Docket No. 50-220

RE: NINE MILE POINT NUCLEAR STATION UNIT NO. 1

Enclosure:
Burnup-Dependent Correction
for Fission Gas Release
Models

FIGURE 1

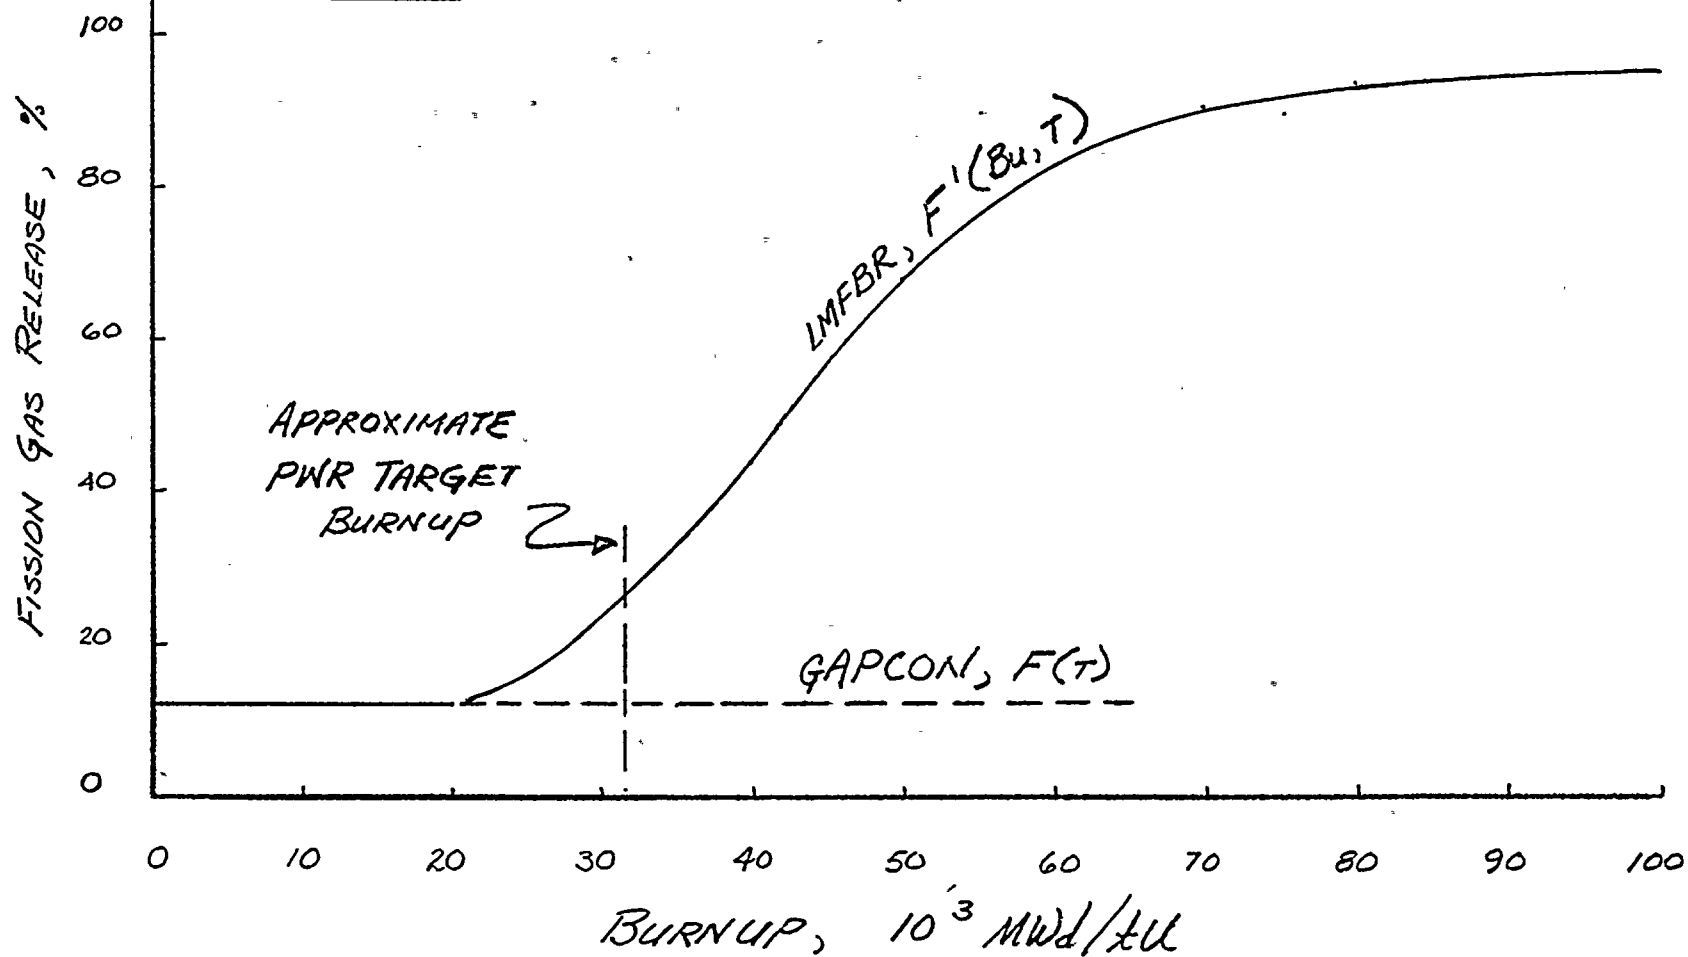
Figure 1 shows schematically how this correction would be applied to the GAPCON gas release model, which is independent of burnup. In the event an existing model contains a burnup dependence, $F(T)$ would be the predicted release fraction under the temperature conditions of interest, but with the burnup variable set equal to 20,000 MWd/tU.
